**CULTURAL RESOURCES OFFICE**  
**PRESERVATION BOARD**  
**REGULAR MEETING**  
**MONDAY, OCTOBER 23, 2023 — 4:00 P.M.**  
**1520 MARKET ST, SUITE 2000, ST. LOUIS, MO 63103**  
[www.stlouis-mo.gov/cultural-resources](http://www.stlouis-mo.gov/cultural-resources)

<b>NEW APPLICATION:</b>	<b>JURISDICTION:</b>	<b>PROJECT:</b>	<b>PAGE:</b>
A. 1 Government Drive .....	City Park .....	St. Louis Zoo herpetarium, ..... solarium, HVAC upgrades	1
<b>APPEALS OF DIRECTOR'S DENIALS:</b>	<b>JURISDICTION:</b>	<b>PROJECT:</b>	<b>PAGE:</b>

**PROPOSED PORCH RAILING**

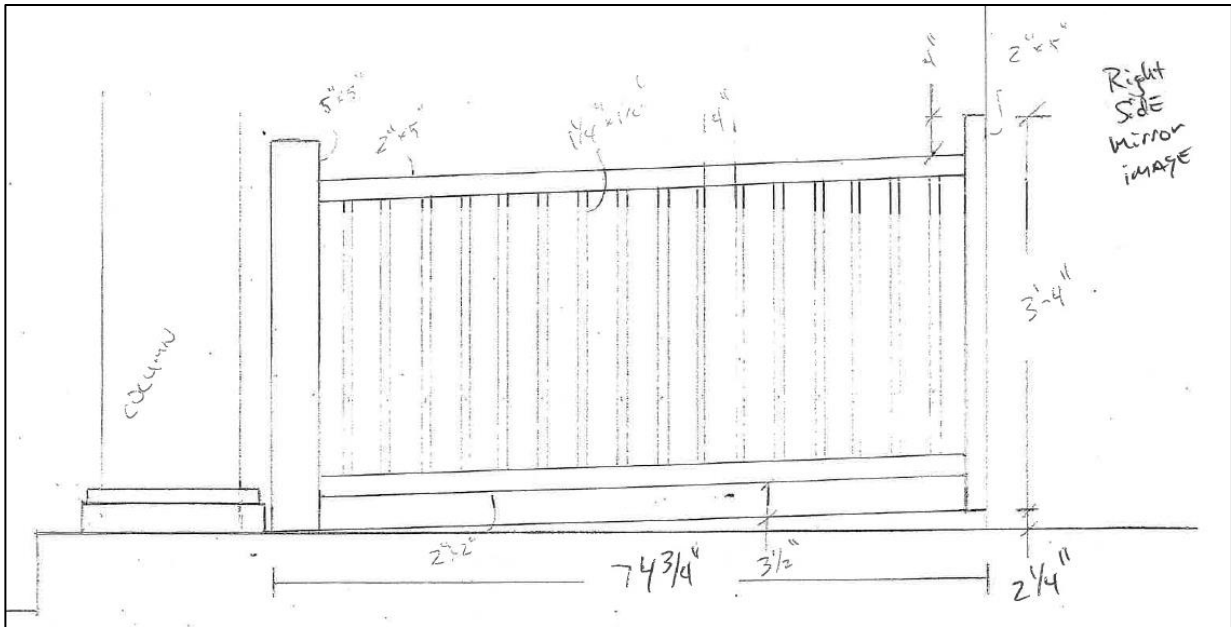
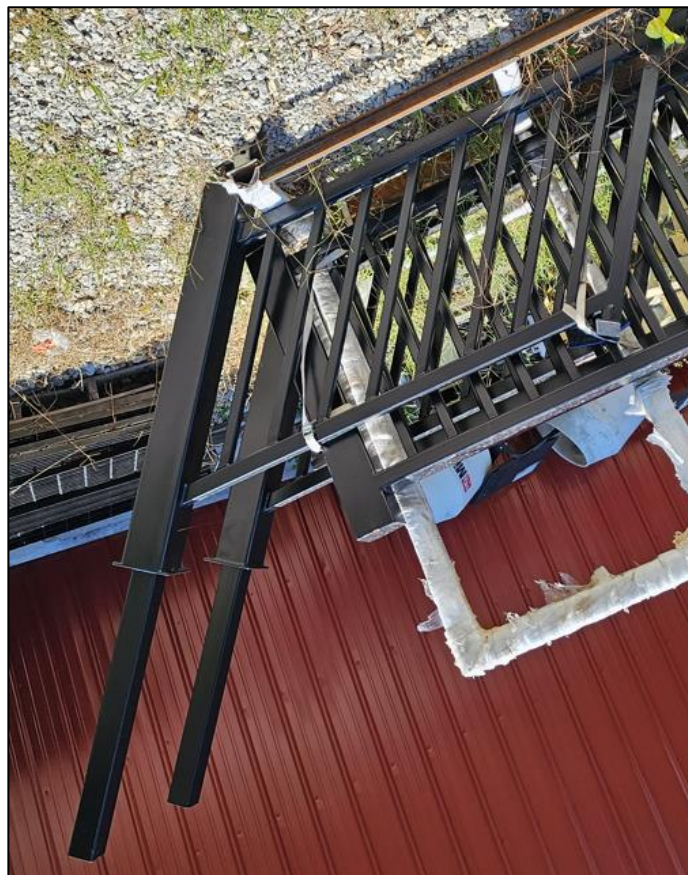
**Does not comply. The proposal to mix metal handrails with a wood porch is not consistent with the architectural character of the district.**

**Does not comply. The existing porch railing would be remodeled in size, design and materials that are inconsistent with the architectural character of the building and wood porch.**

**Does not comply. The proposed replacement handrails on the wood porch and on the premise steps would be metal and, even if painted, would not resemble the original, or any historic example.**

**Does not comply. The proposal would replace wood handrails with metal.**

That the Preservation Board uphold the Director's Denial of the permit to install metal handrails as the proposal does not comply with the Skinker-DeBaliviere Historic District Standards.

PROPOSED SITE PLAN

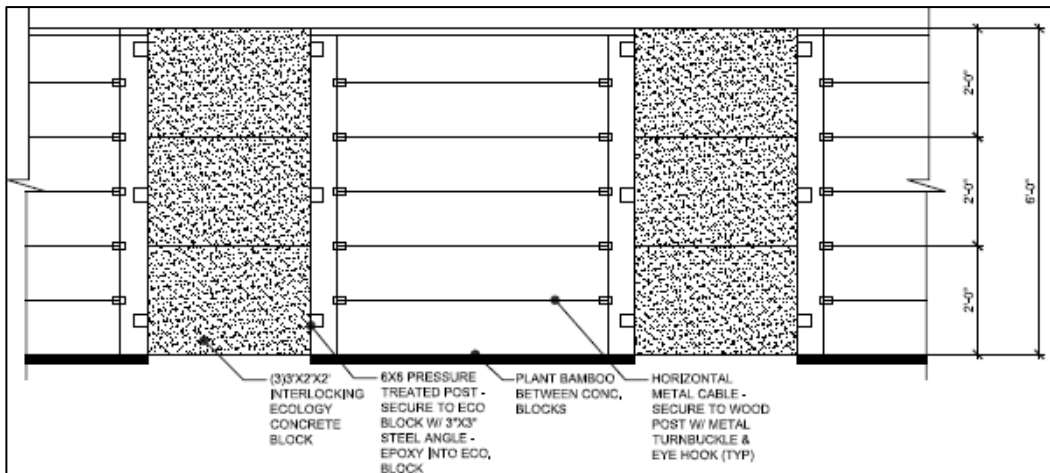
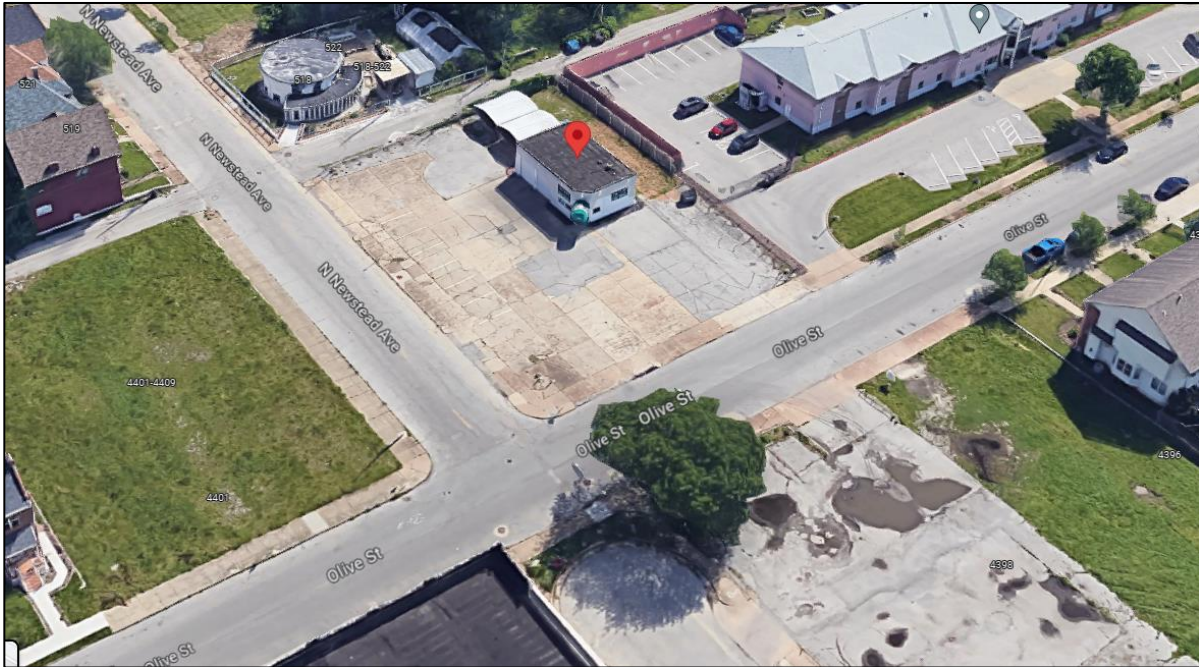
**Partially complies. The proposed fence is a combination of wood, bamboo, concrete block, and metal cables. The first two materials, wood and bamboo, are permitted, but concrete block and metal cables are not and therefore would be not be compliant.**

**Does not comply. The proposed 6-foot high opaque fence would be situated in front of the primary structure and would not be compliant. Even though the code offers possible exceptions for corner properties, staff does not believe that this proposal merits an exception, as the design's opacity is the aesthetic choice of the property owner and there are a number of other more visually-permeable fencing options that would comply with the standards.**

That the Preservation Board uphold the Director's Denial as the proposed fence does not comply with the Central West End Local Historic District Standards.

PROPOSED HORIZONTAL FENCE DESIGN

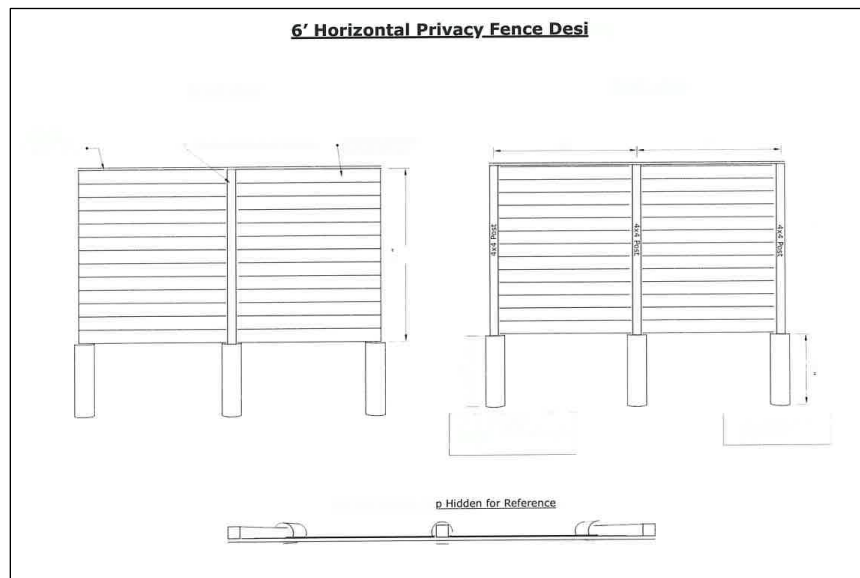
**Does not comply. The proposed fence has horizontal boards instead of vertical. No Model Example has been submitted for the fence design.**

That the Preservation Board uphold the Director's Denial as the horizontal fence does not comply with the Benton Park Local Historic District Standards.

**PROPOSED NORTH ELEVATION**

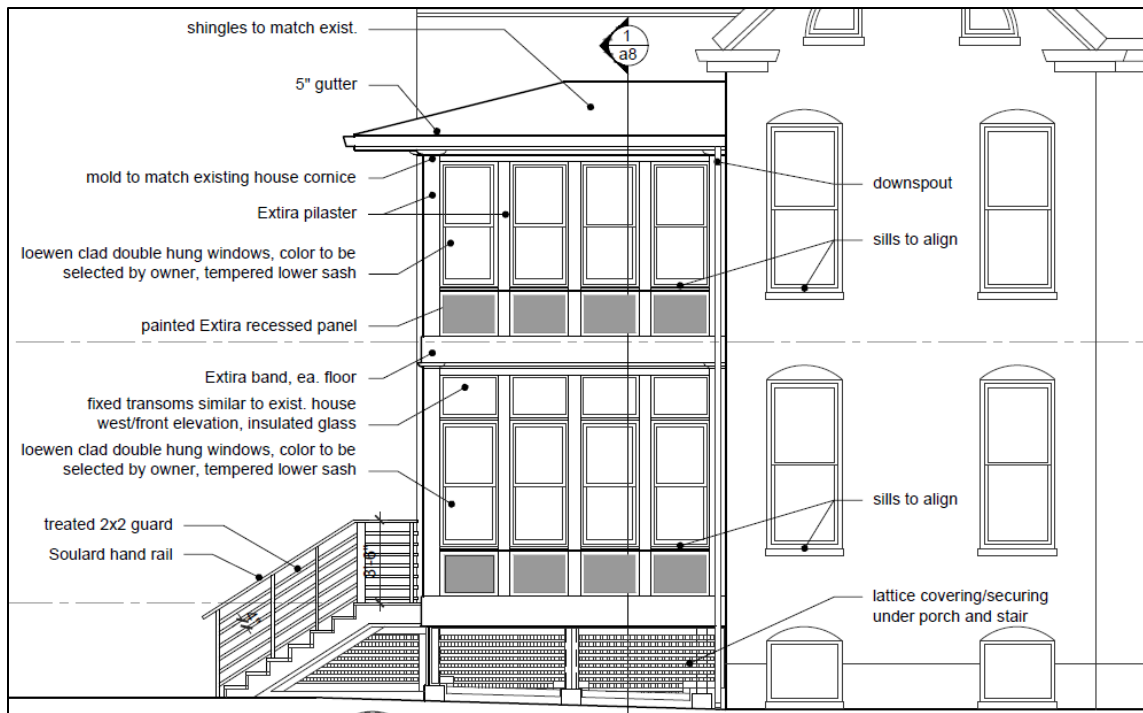
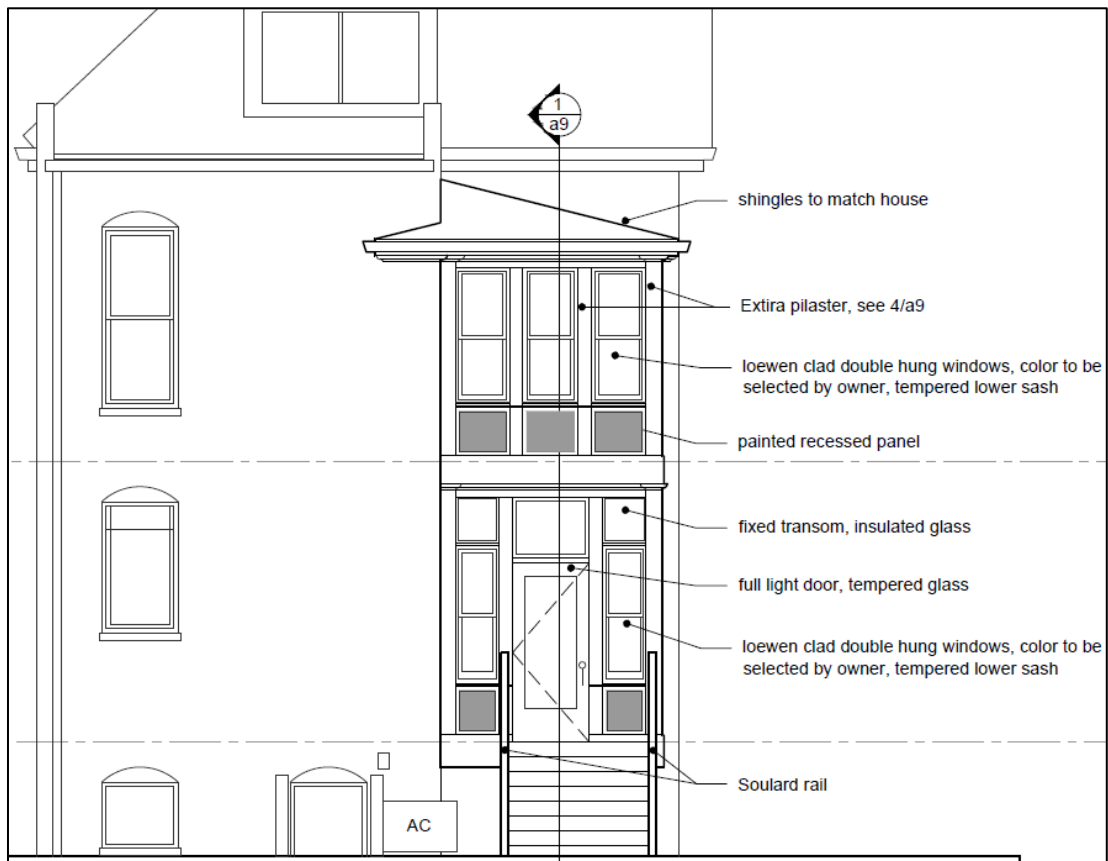
**Does not comply. The proposed new porch would be located on a Public Façade. However, it should be noted that the applicants have worked with CRO staff and the neighborhood review committee to produce a design that is complementary to the building and the streetscape. Though not technically compliant with the standards, the revised design would otherwise be appropriate in scale, materials and detail.**

That the Preservation Board uphold the denial to construct a 2-story enclosed side porch at a Public Facade, as it does not meet the Benton Park Local Historic District standards for new appendages to Public Facades.
